BW1 Block Diagram

Size Custom	Document Number	Alviso VGA/DMI (2/5)		Rev 4A
Date:	Thursday, August 11, 2005	Sheet	5 of 72

Rev.	Date	Phase	Change List
1A	2005/1/4	DV	Initial release
2A	2005/2/5	SIV	See page 69 Record A
3A	2005/4/25	SIT	See page 71 Record B
4A	2005/7/5	SVT	See page 72 Record C

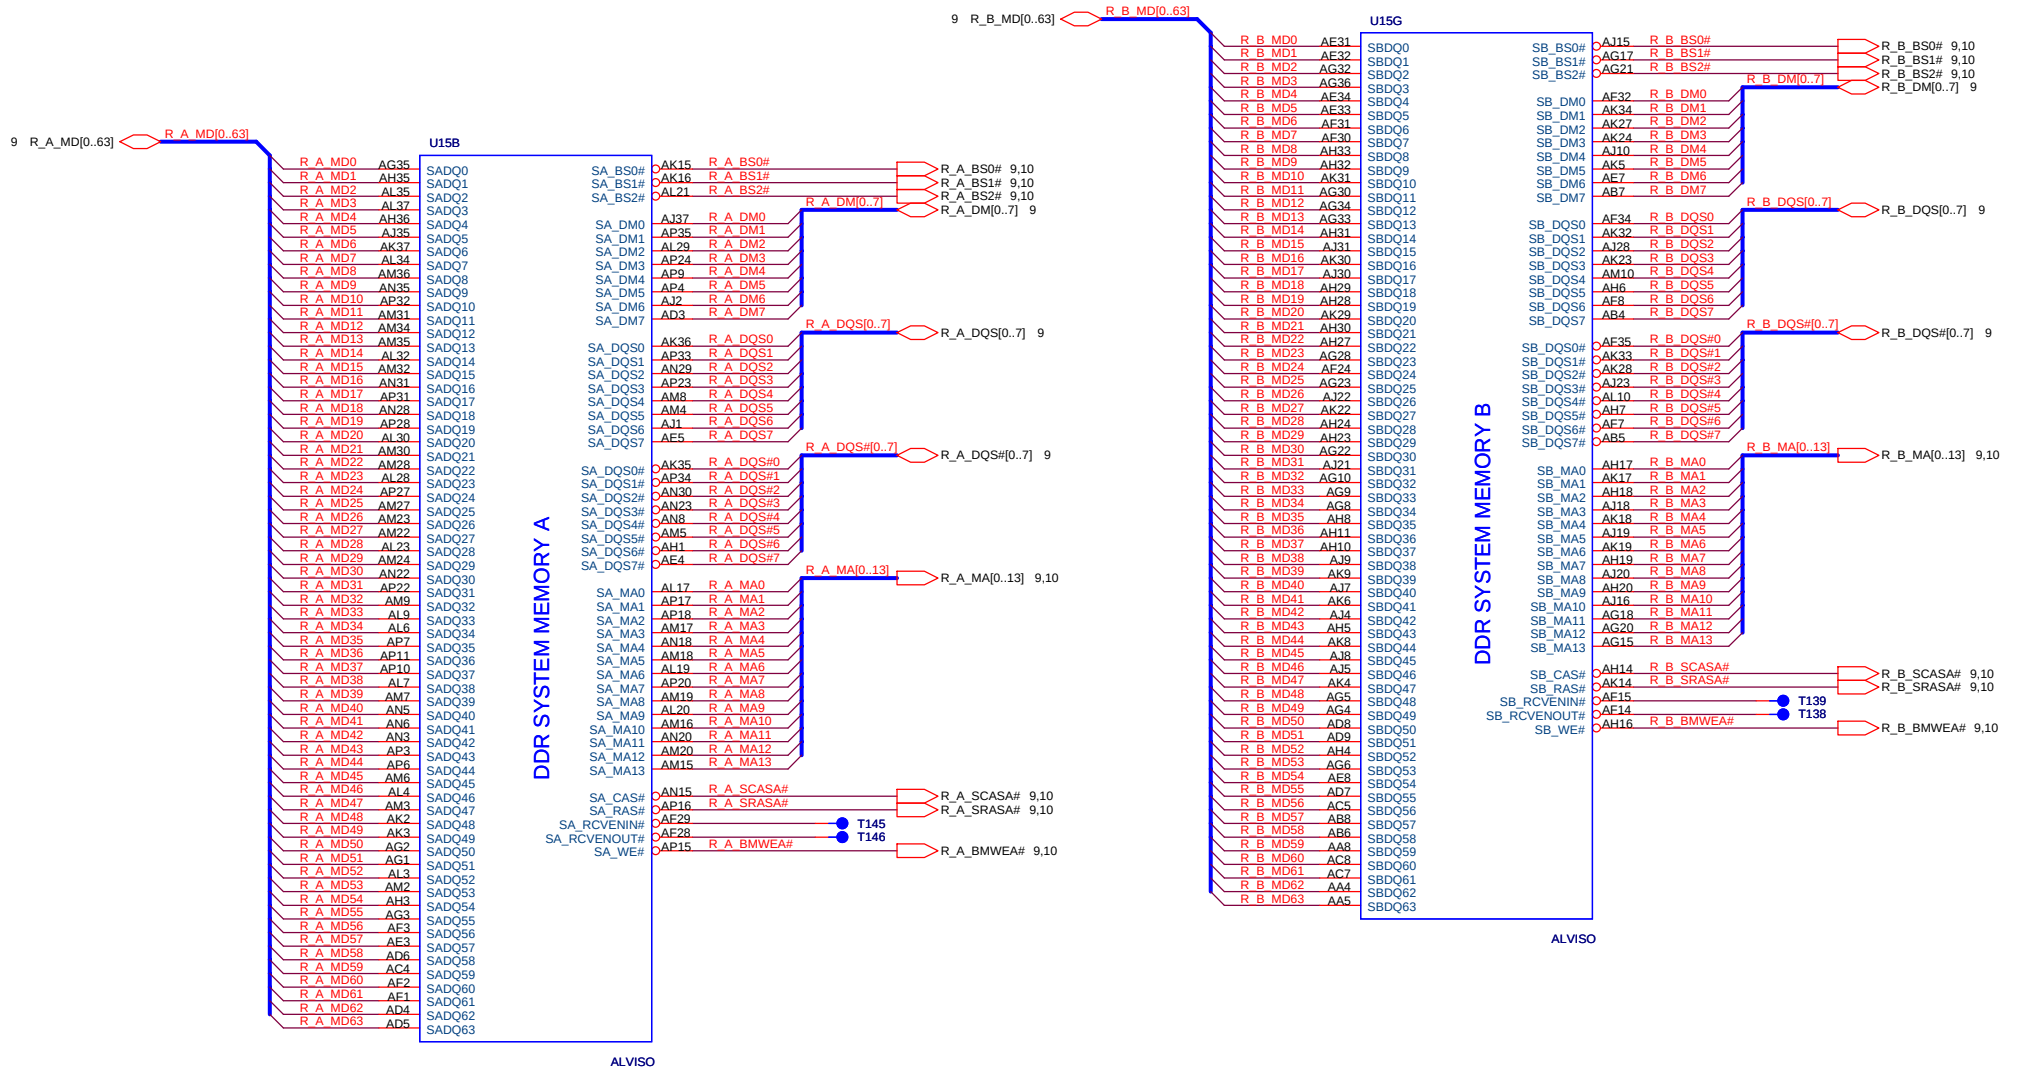
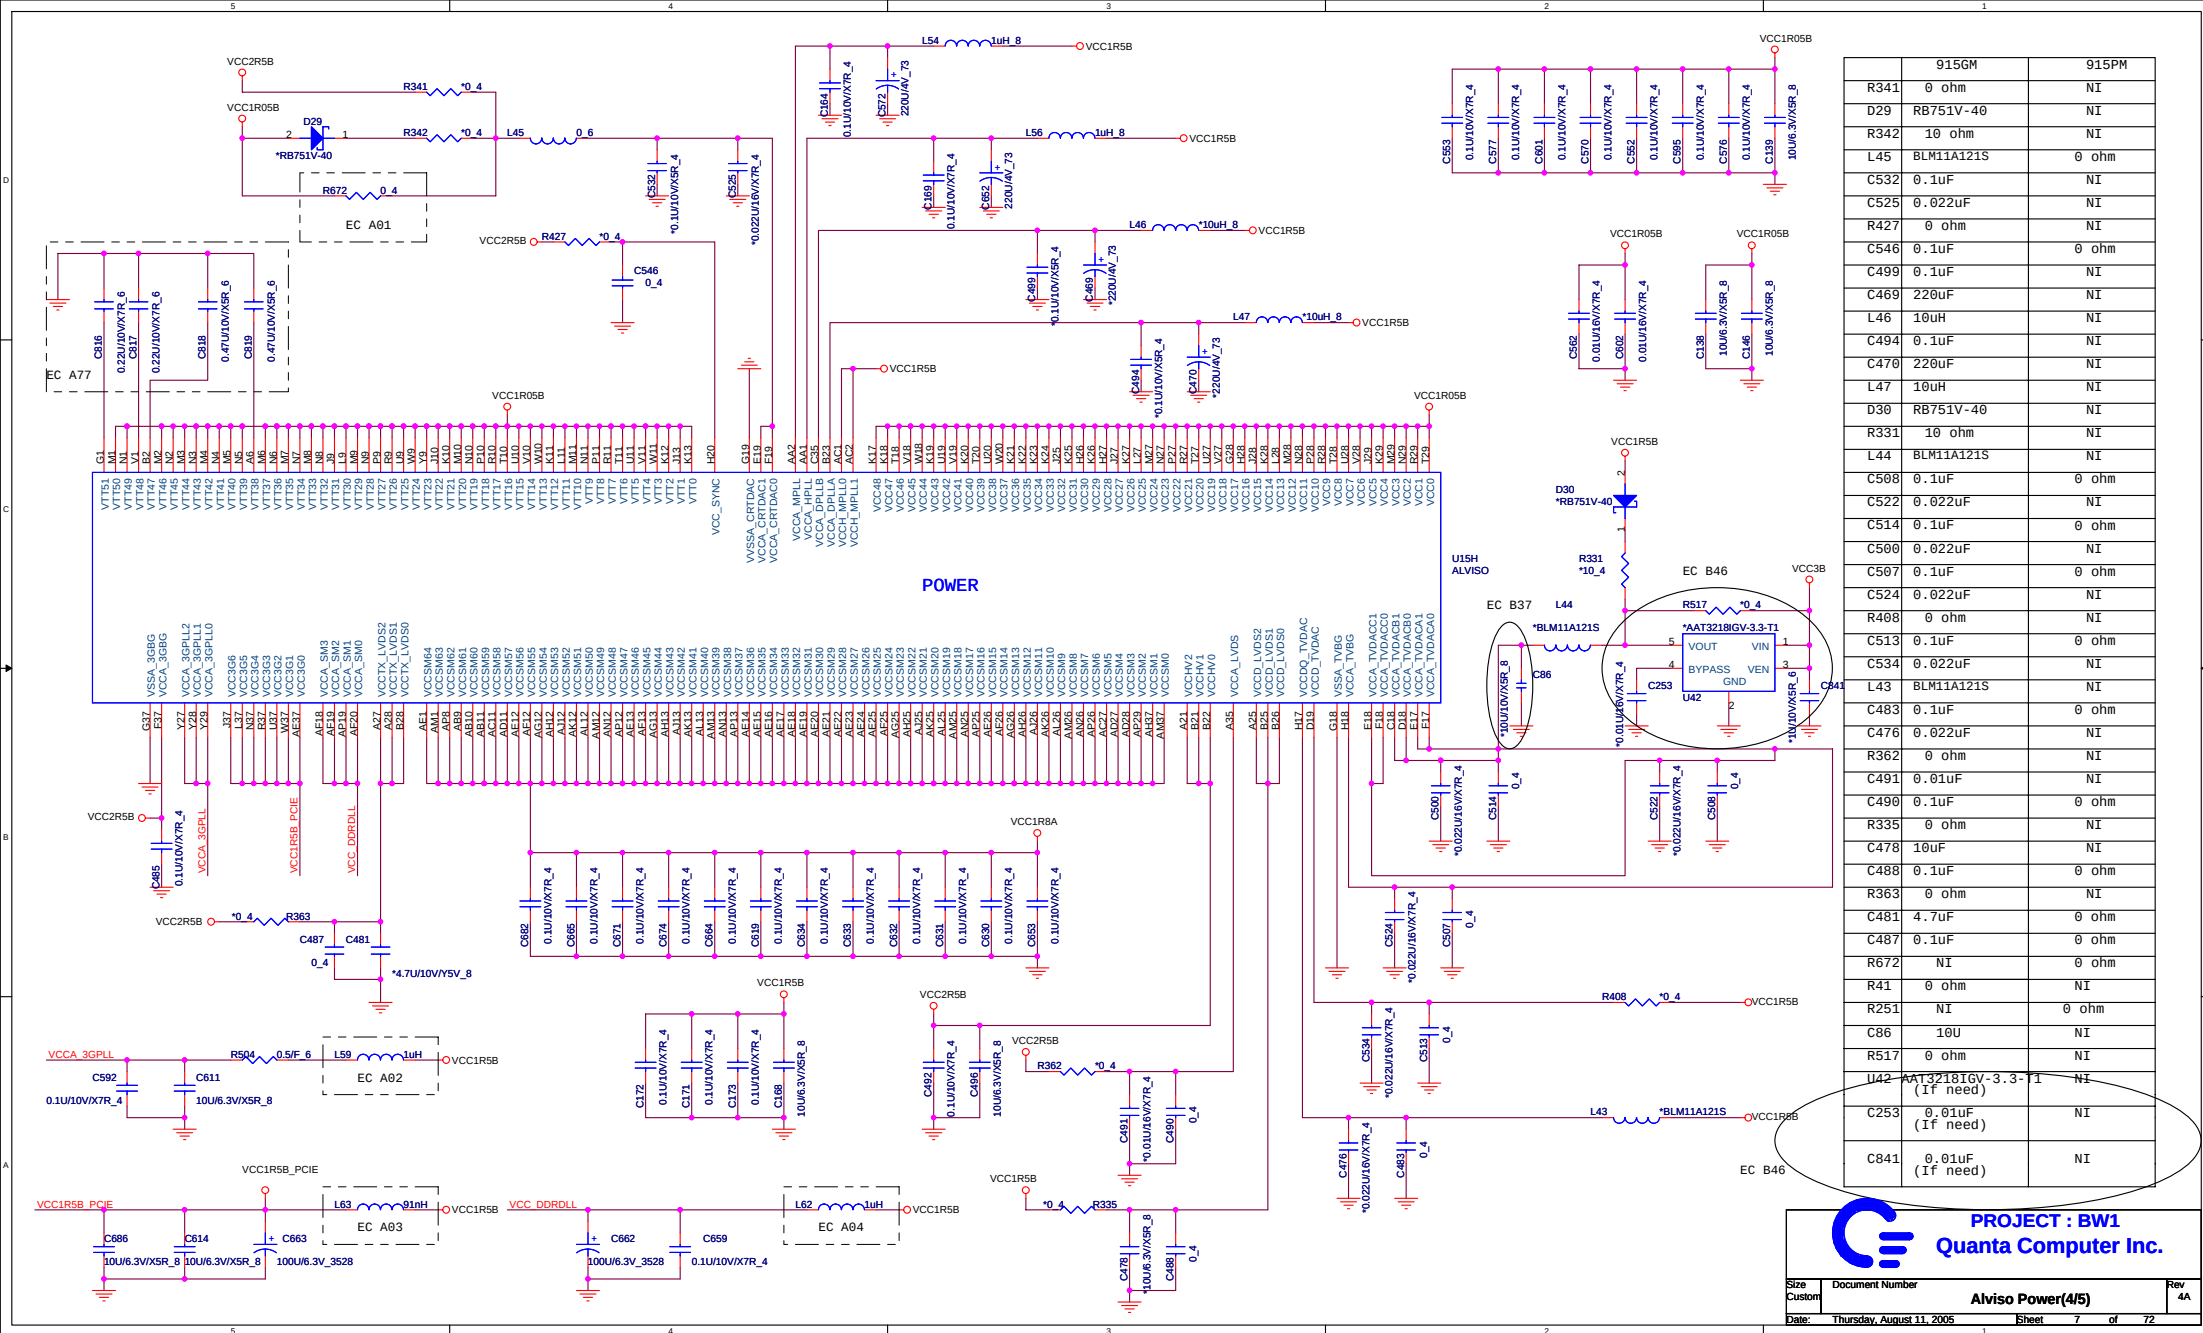
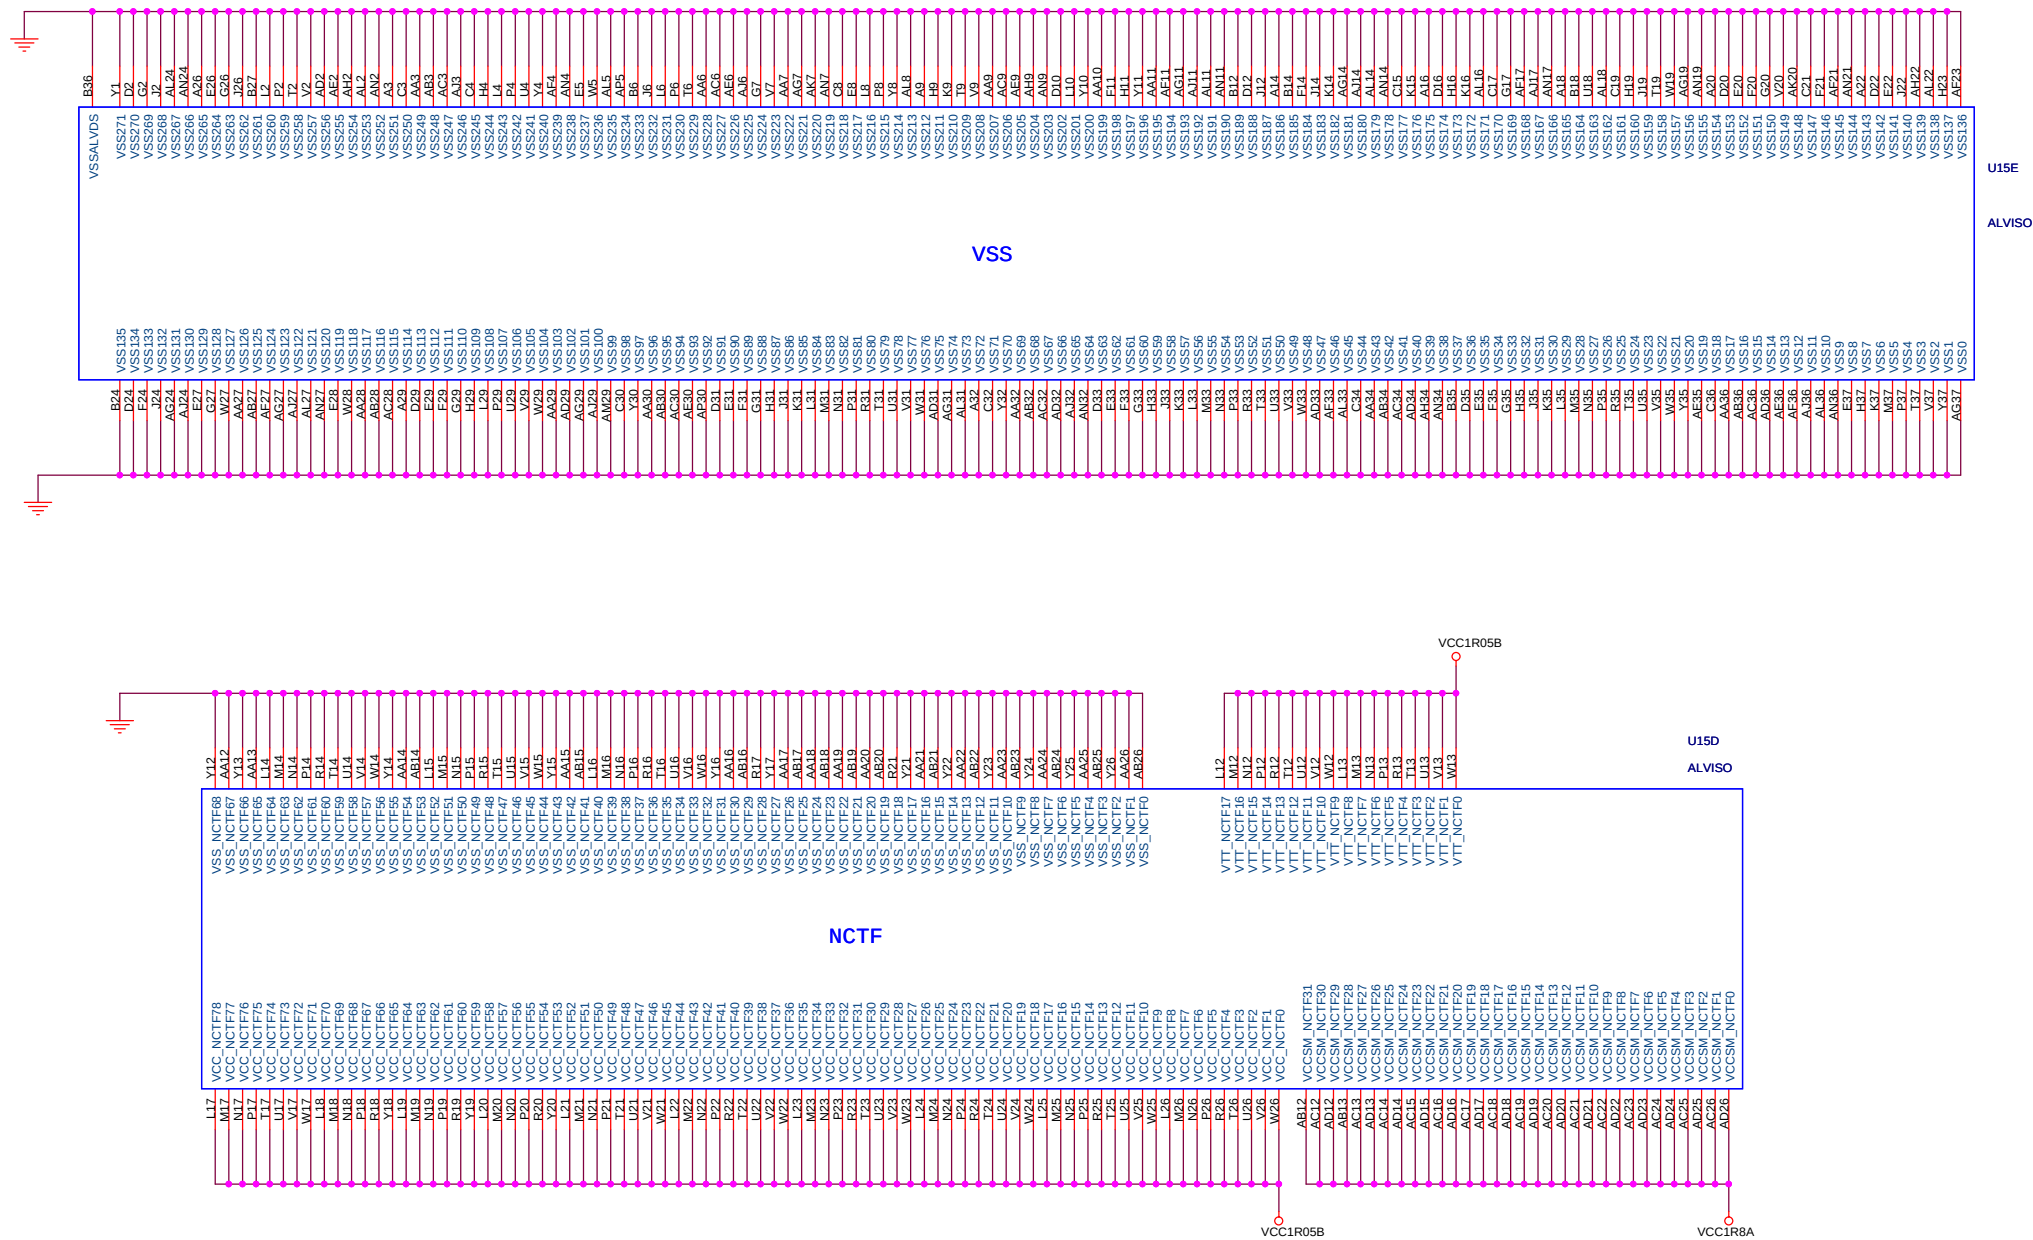
EC A66

EC A65/37/Size of resister R33 on LAN_MAG_TAP changes to 1608 size.(IBM EC)
EC A66/5/Change termination resister R364 for Alviso composite TVout from 150ohm to 75ohm.(IBM EC)
EC A67/37/Delete a gate logic from docking PCIE_WAKE# signal.(IBM EC)
EC A68/16,23,27/change value of resistors and signal name on Azalia interface.(IBM EC)
EC A69/25/Add internal MIC Bias logic.(IBM EC)
EC A70/12/Change diode to cheaper one.(IBM EC)
EC A71/50/PJ2(DC-IN connector) change to right-angle type.
EC A72/52/PJP2,PJP3(Battery conn.) change to 7-pin. type.
EC A73/55/PL12 change to GANSHIN(CDRH104RNP-5R2NC-EP).
EC A74/12/ATI TV-OUT termination R304,R308 change to 150 ohm.
EC A75/12/Add R683=0ohm, change R195,D19 to NI per Atmel recommend.
EC A76/32/R109 change to 1K,R115 change to 1.2K,C156 and C166 change to 12pF to pass IEEE test.
EC A77/7/Add C816-C819 edge capacitors to meet Intel design guide.
~~EC A78/11/Install U10,U11,U42 and change to TC7SZ08.Change damping resistors' value to solve PCI clock slew rate too slow issue.~~
